SAN JOAQUIN RIVER
RESTORATION PROGRAM

Seepage and Conveyance Technical Feedback Group Meeting

February 8, 2013

SMP PEER REVIEW PANEL FINDINGS

Suggested changes to Table 3

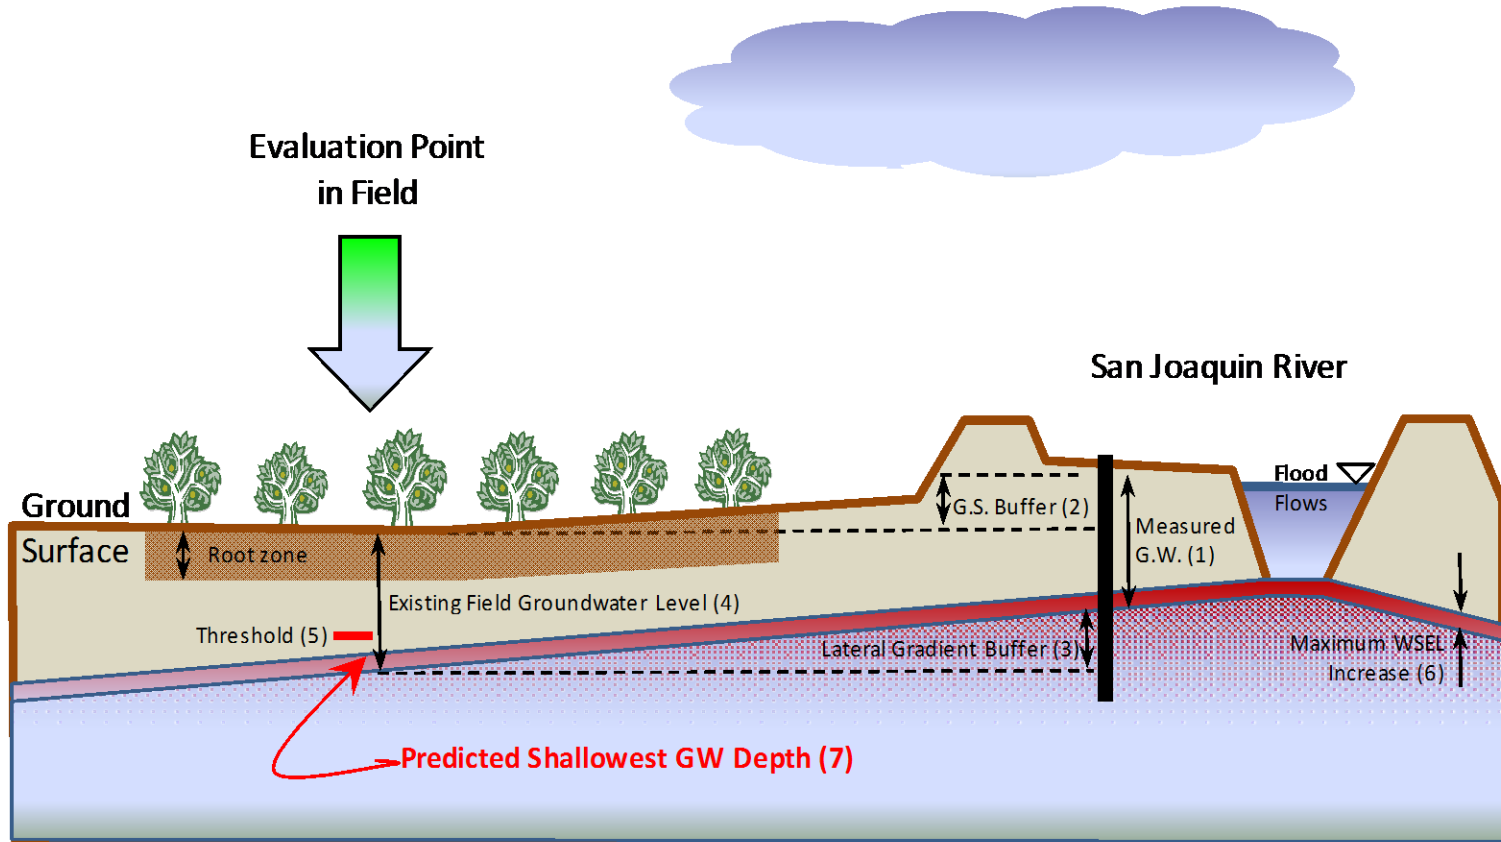
Method 1 - Increase in Stage Evaluation of Field Threshold

- The current practice of assuming a 1 ft increase in the River bed water surface (WSEL) equating to a 1 ft rise in a nearby observation well is overly conservative. Even in instances where significant hydraulic communication is evident, there is typically a time lag between the river rise and the water table response.
- The key problem is the variability of timing of the groundwater movement. Although the groundwater response time is a function of the rate of porous flow through the connecting aquifer layer, the response can be more rapid in situations where elevated river stage blocks regional groundwater flow.

Suggested changes to the Rating Curves

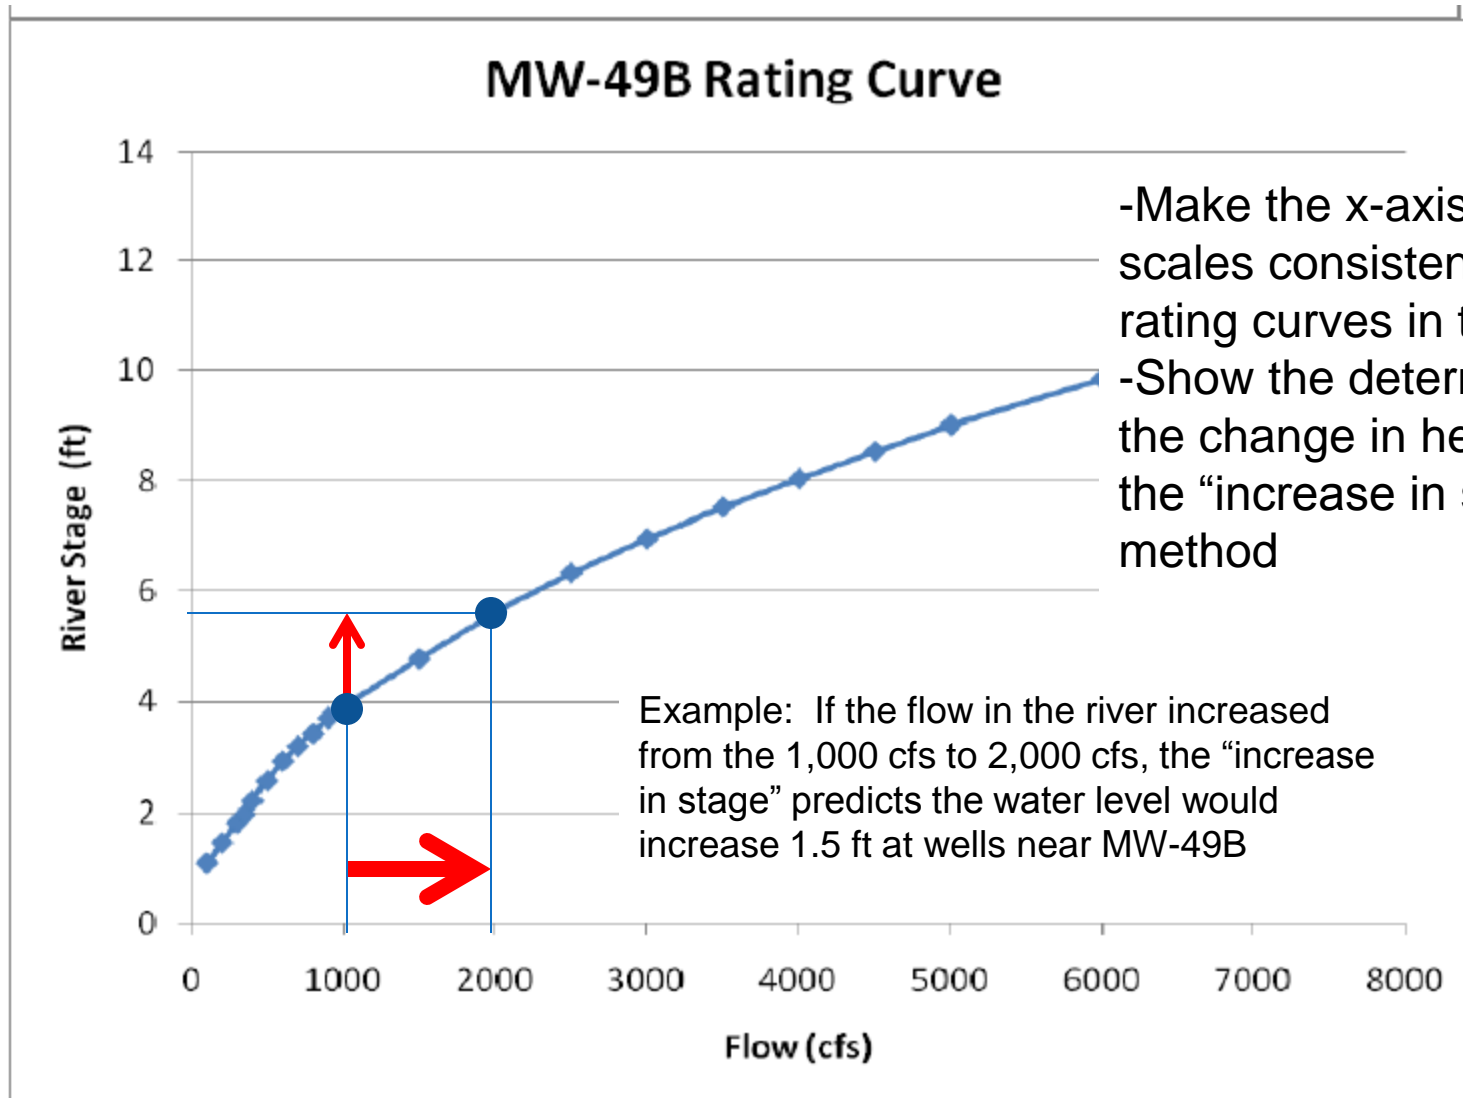
- The use of HEC-RAS is appropriate for estimation of travel time and flow attenuation - the SMP doesn't clearly describe how the travel times or flow attenuation were verified and the steps taken to calibrate the HEC-RAS model.
- In the Flow Bench report, the graphs generated by the HEC-RAS data should be standardized. Currently, they have different scales reported on both the x-axis and the y-axis.

Figure 12

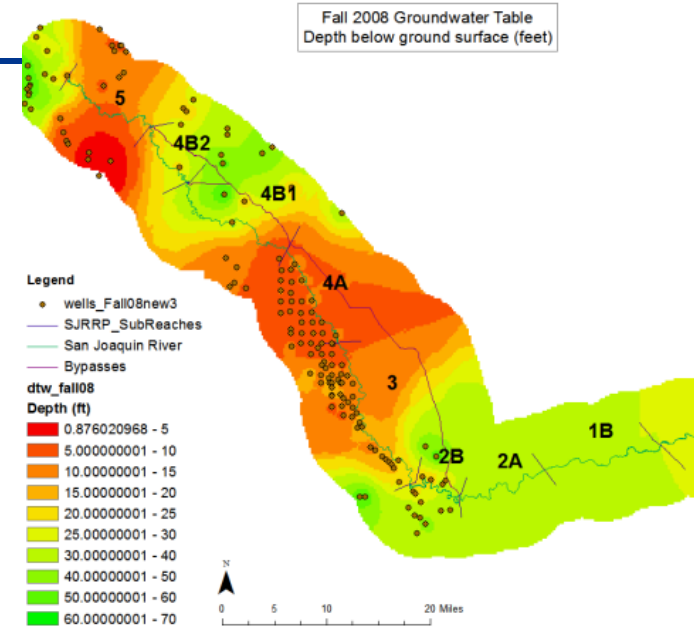
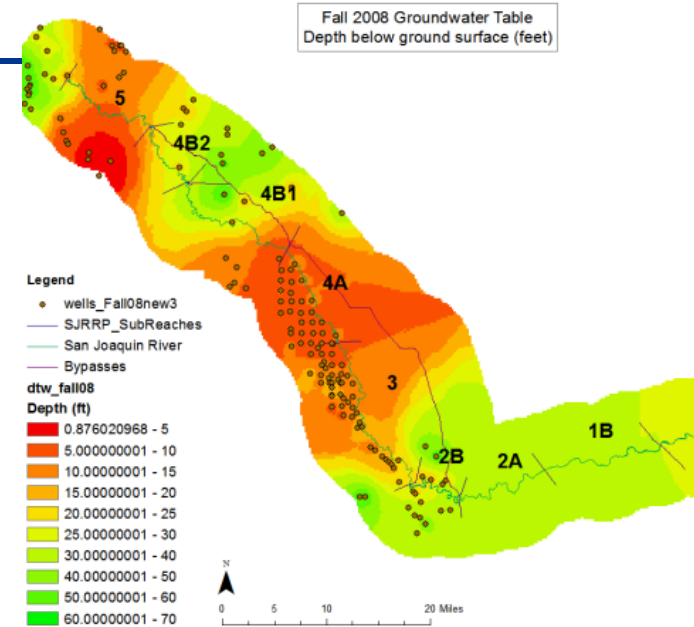
- Historical GW maps are sound.
- Recommend adding methods that refine and reduce potential errors caused by human, spatial density and interpolation techniques used to create maps.
- Adopt a guideline for minimum spatial density used for all maps.

- Recommend Reclamation consult historical published reports including Soil Survey, predevelopment maps, other observed seepage records.

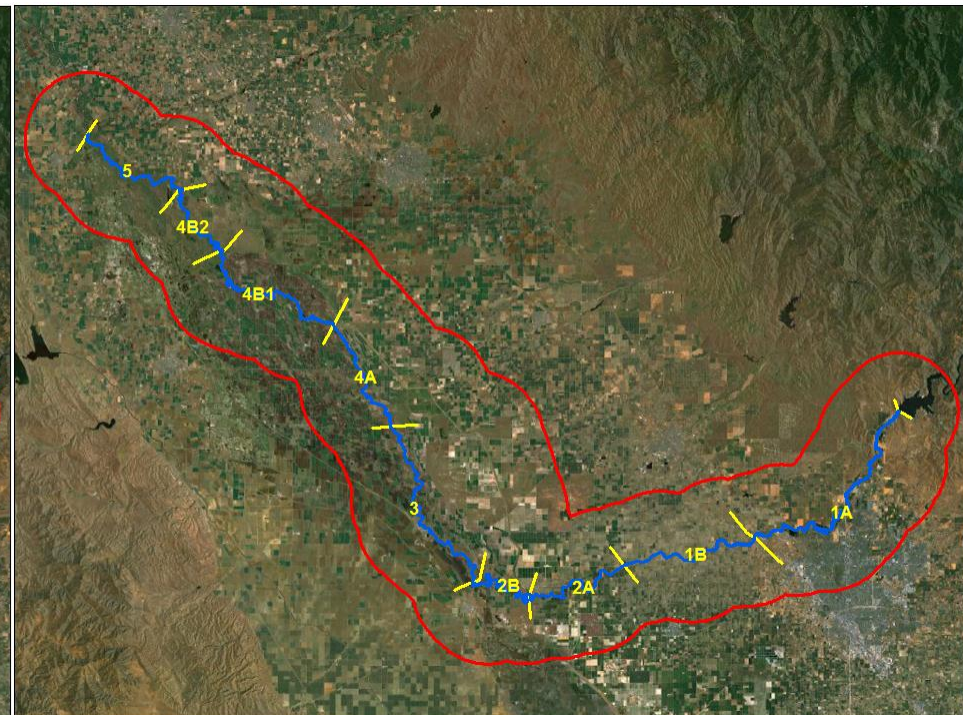
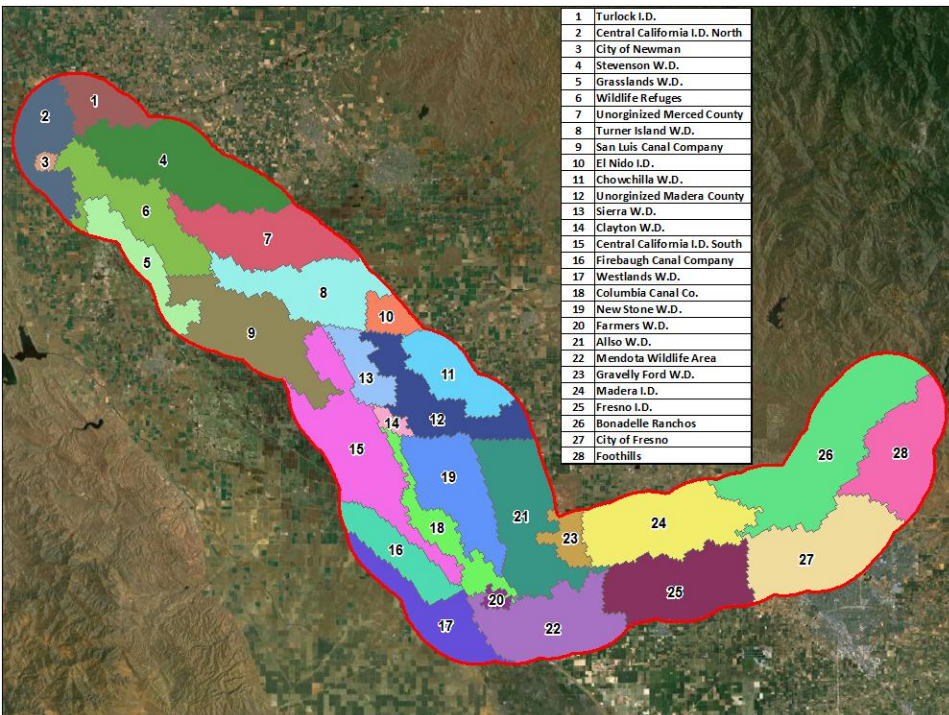
- Historical WT Maps are valuable but do not clearly address the magnitude and scope of the seepage problem.
- Need context and explanation

Figure H-7
Thresholds developed using historical groundwater-level measurements in CCID Well 191

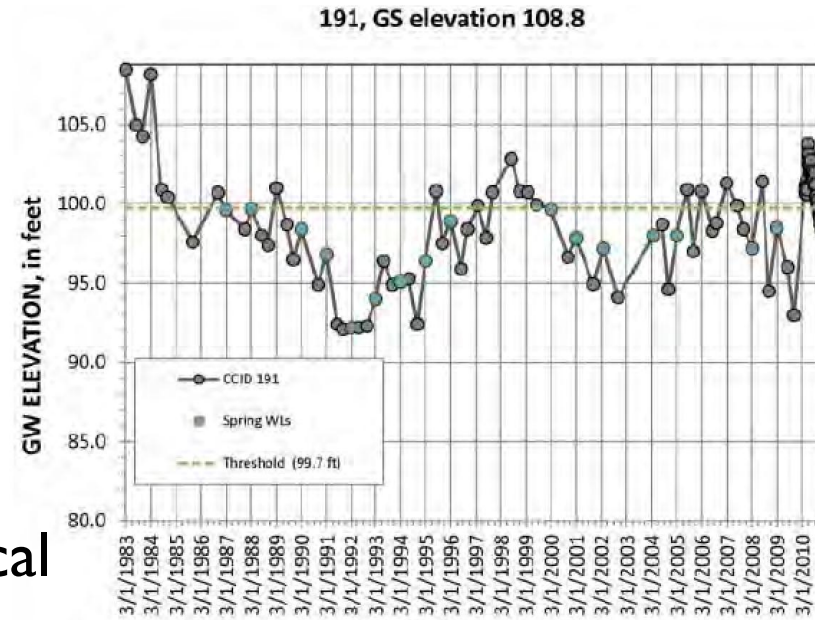
- Generally, historic levels are reasonable and help establish SMP thresholds.
- But depending on year type, historical levels could be overly conservative and potentially limit releases.
- Establishing year-type indexing will help evaluate what is or is not conservative

Thresholds – Historical Method

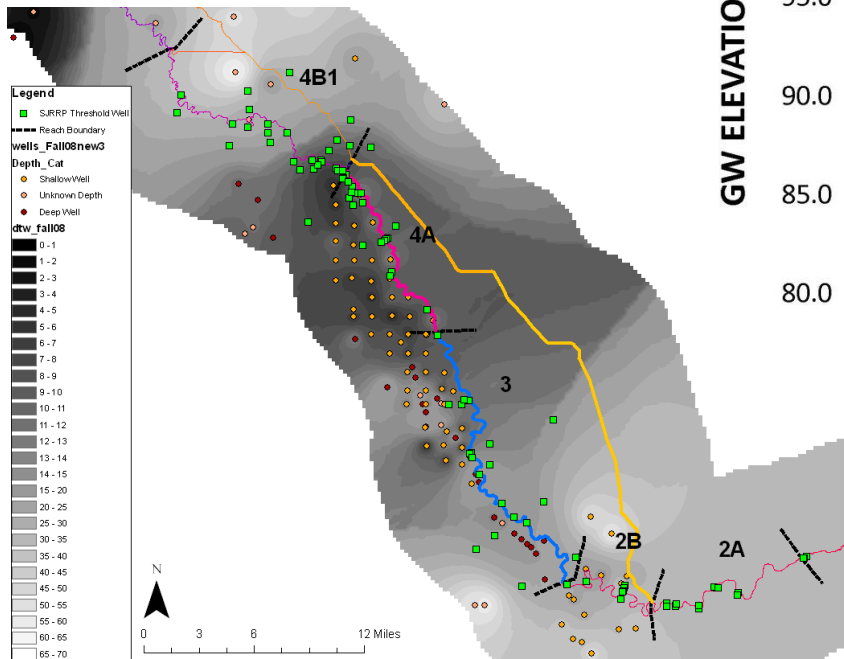
- Peer review panel states historical threshold method is reasonable
- Lack of pre-project shallow wells in area with shallowest water table
- Use 2012 data to represent pre-project conditions – i.e. without flow in the river
- Implemented in Reach 4 only

1. Obtain 2012 data
2. Determine flood irrigation events (from well monitoring field notes)
3. Determine precipitation events (from Los Banos CIMIS data)
4. Determine infiltration time (based on soil textures)
5. Remove data points caused by flood irrigation or precipitation within the infiltration time period
6. Set the threshold at the highest remaining groundwater level
